**SAN ANTONIO WATER SYSTEM  
DOS RIOS WRC RE-RATING  
HEADWORKS IMPROVEMENTS AND  
PROCESS ENHANCEMENTS PHASE I  
SAWS Job No. 08-6502  
SAWS Solicitation No. B-10-057-DD**

**ADDENDUM No. 3  
December 9, 2010**

**EXISTING MCC (MCC SG-1)**  
SCALE: NTS

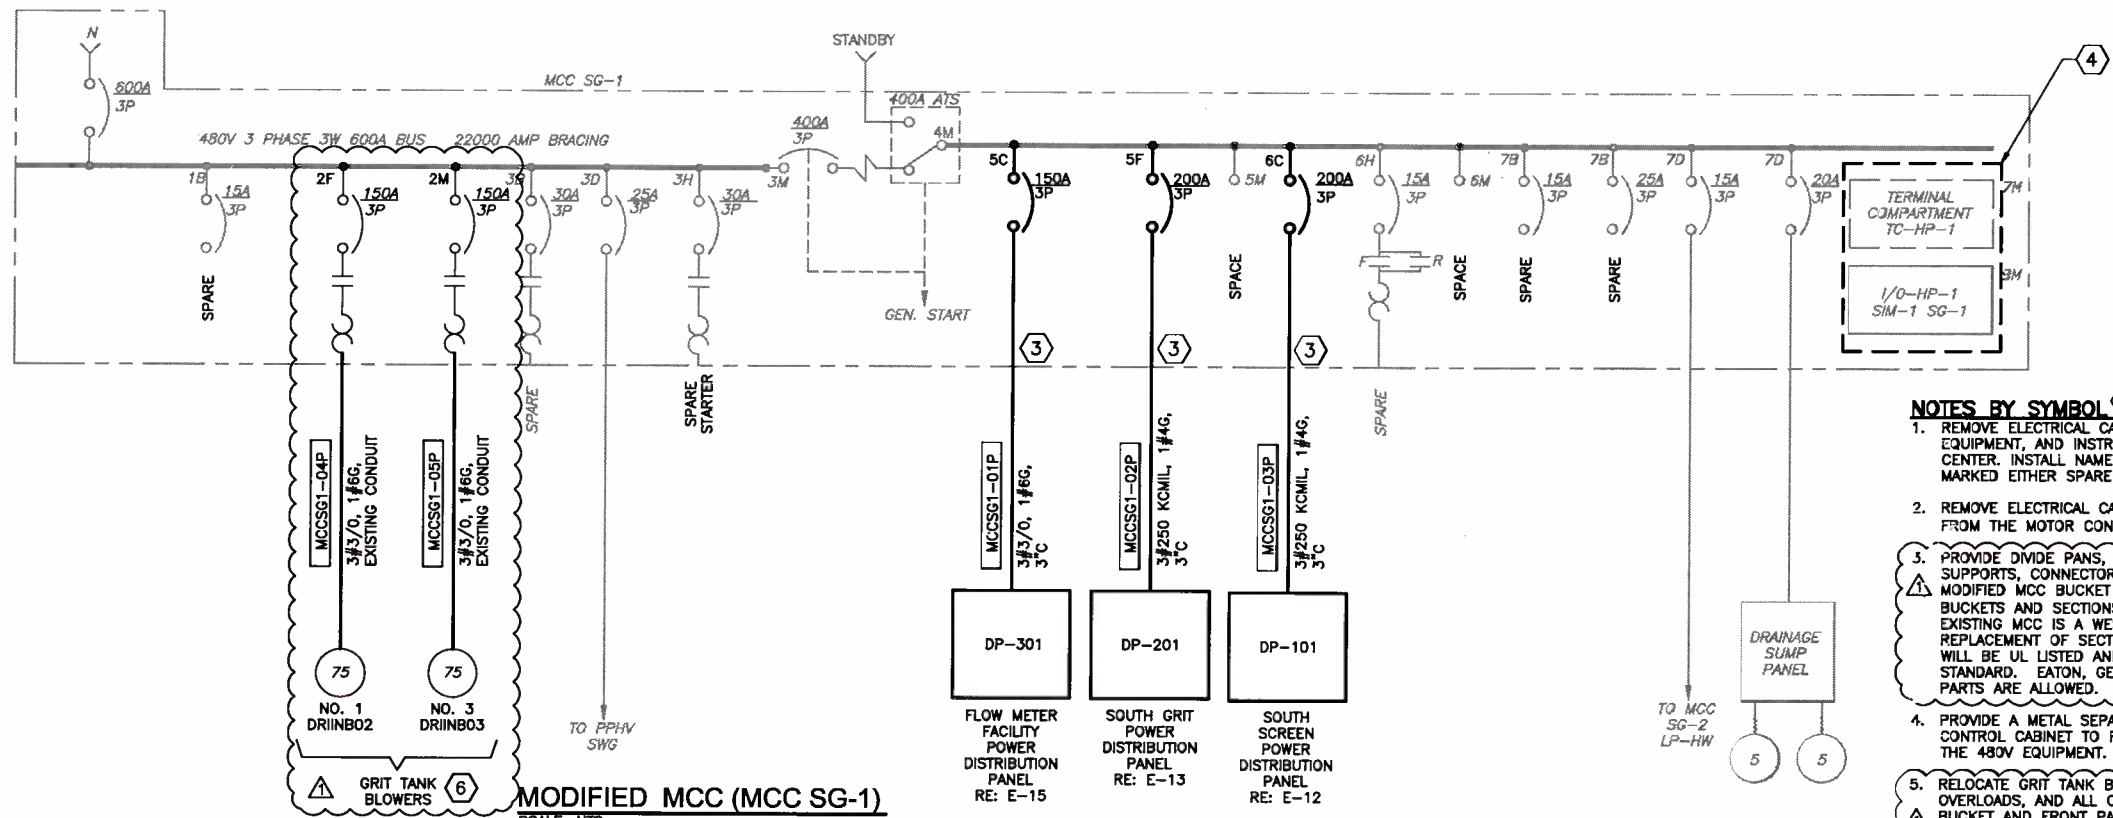
SHEET E-8 – MOTOR CONTROL CENTER SG-1 ONE-LINE DIAGRAM

**INFLUENT FLOW METERING  
 FACILITY POWER DISTRIBUTION  
 ONE-LINE DIAGRAM**

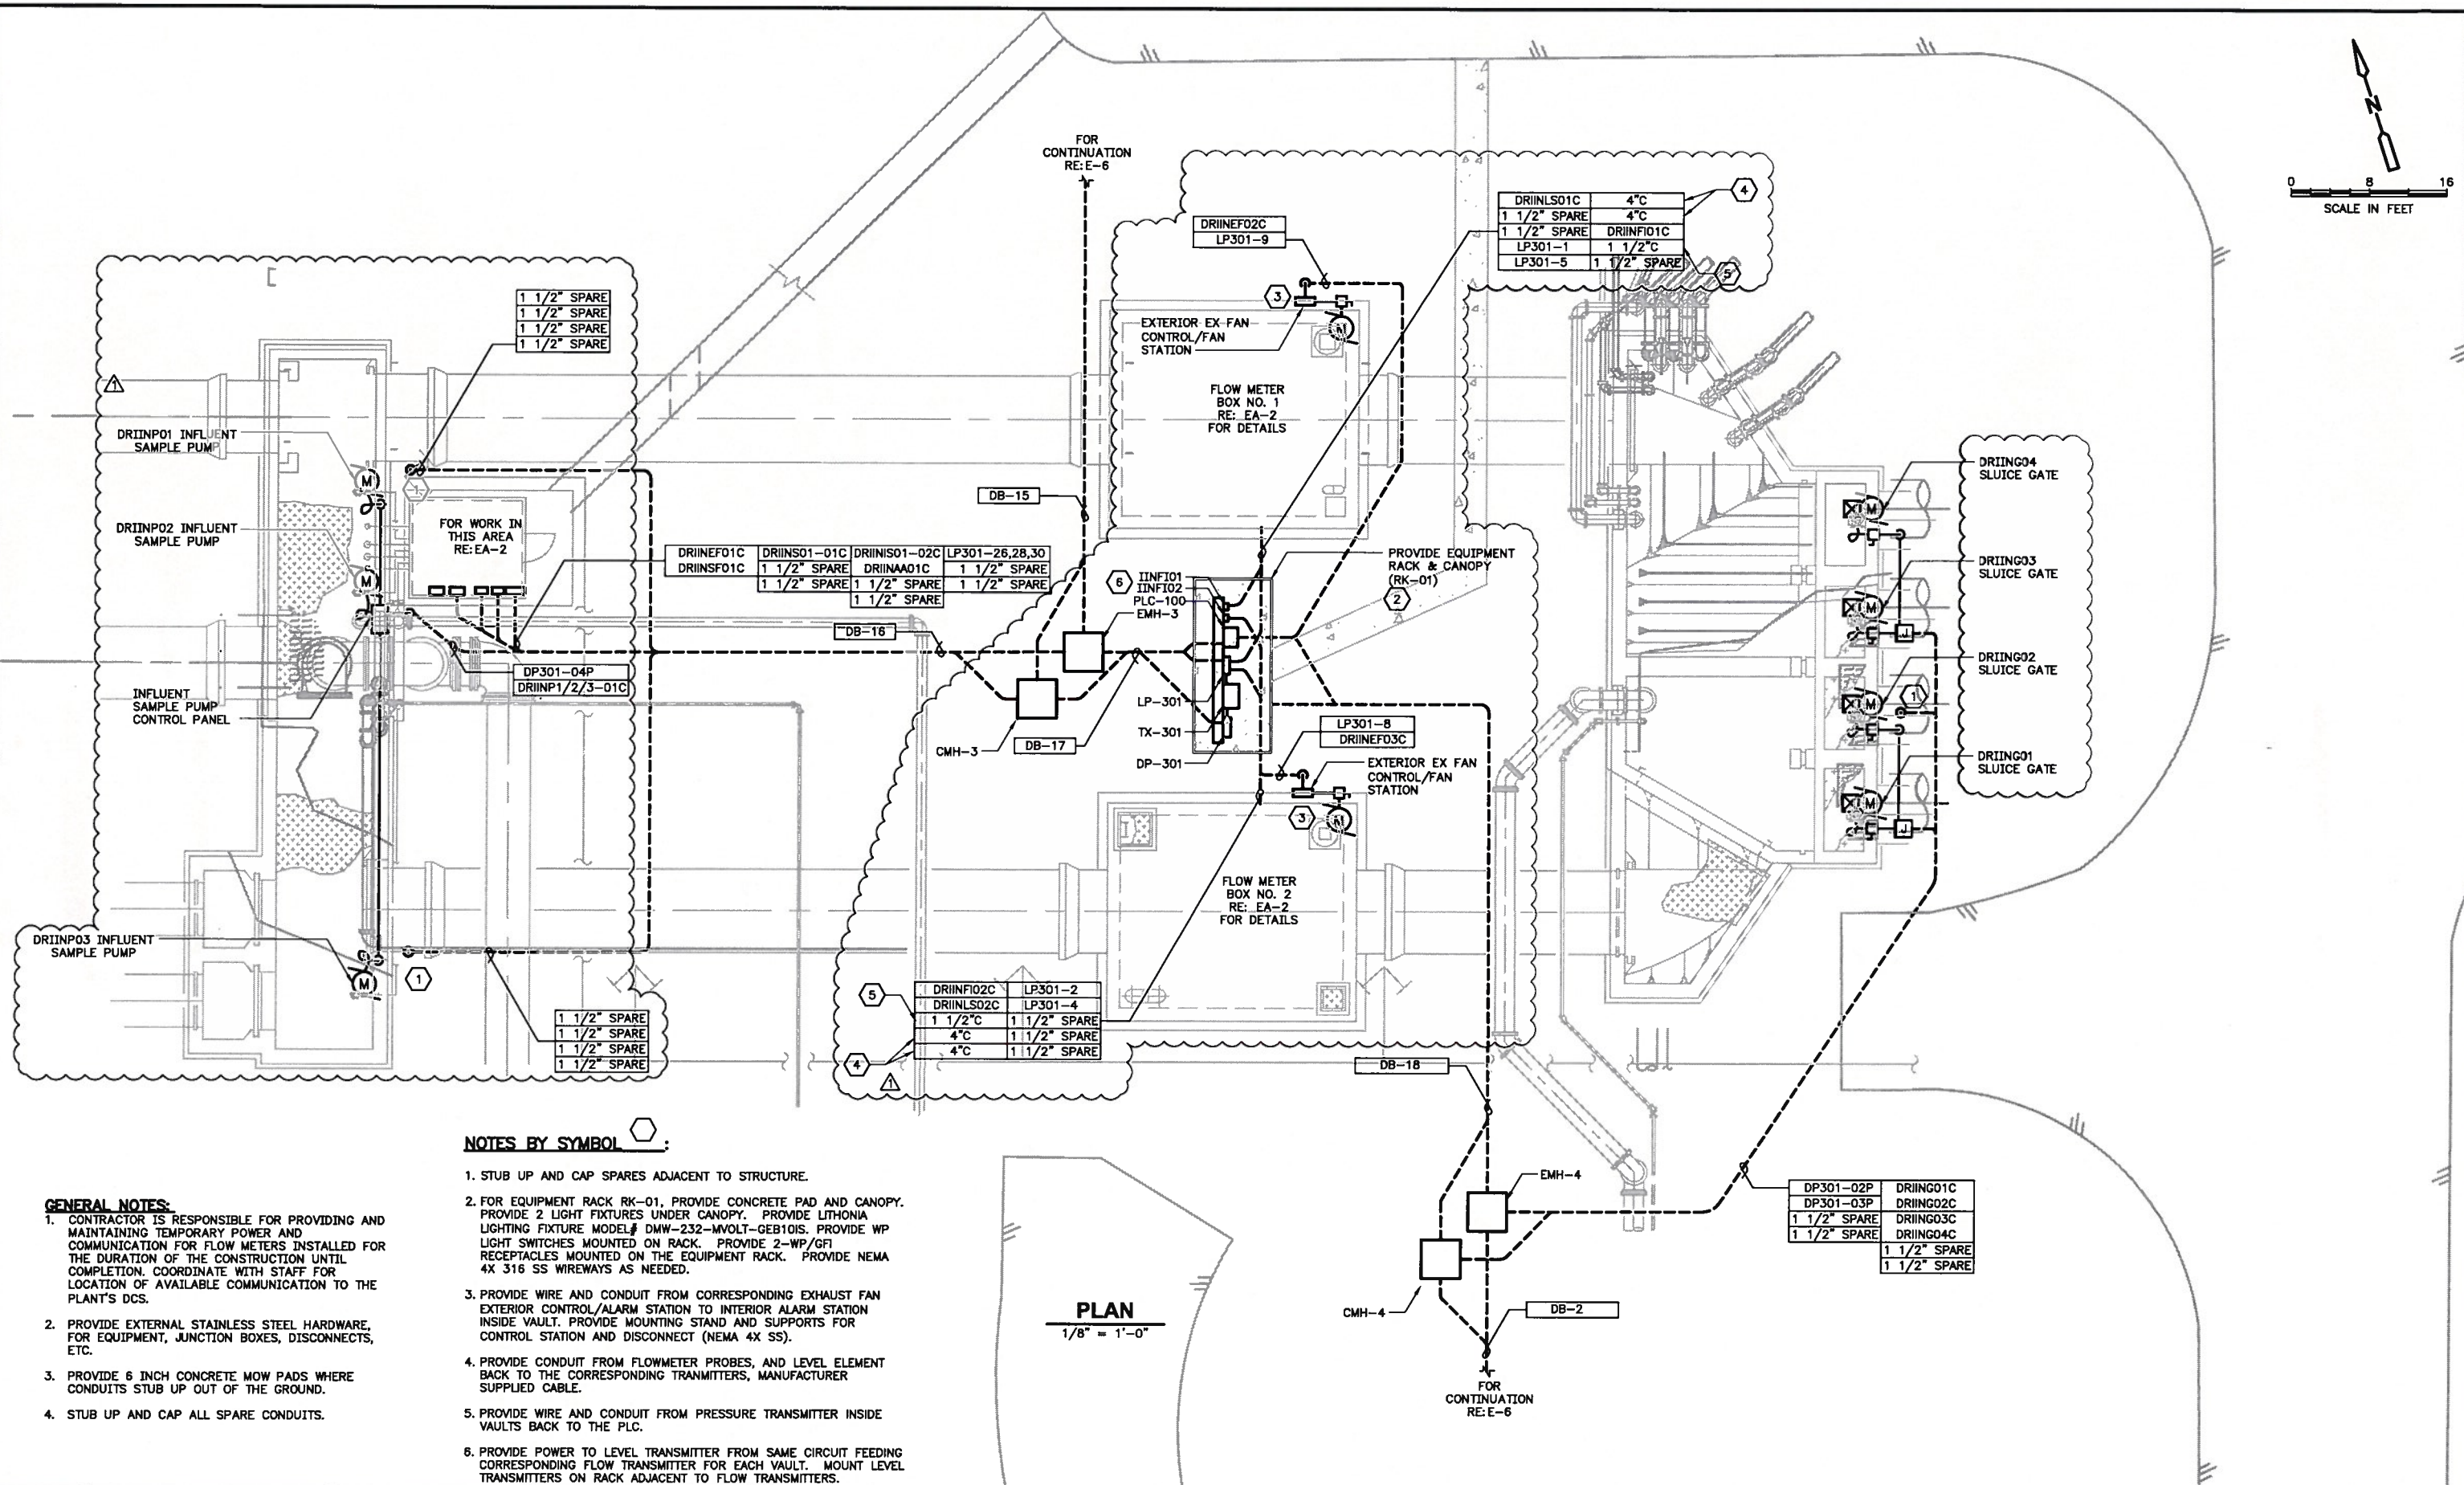
**Q2. On Sheet E-15, why are the three (3) combo starters feeding the Sample Pumps shown as dashed lines?**

A2. Dashed lines represent the combination starter enclosure. Refer to revisions to Sheet E-15 for changes to Sample Pumps (which will be provided as part of this addendum).

**ODOR CONTROL BUILDING POWER & CONTROL PLAN**  
SCALE: 1/4"=1'

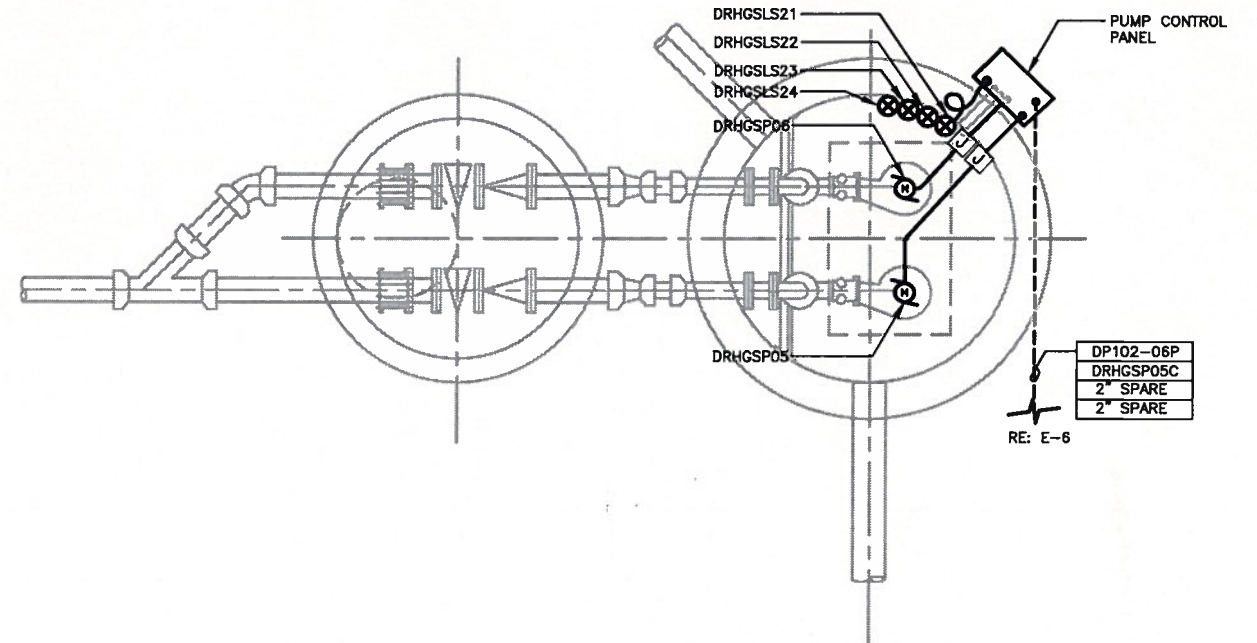
**Q21. Sheets E-12 and EF-1 show a “Drain Pump Control Panel”. Is this control panel to be provided by the electrical contractor or vendor? If it is to be supplied by the electrical contractor, provide a schematic diagram.**
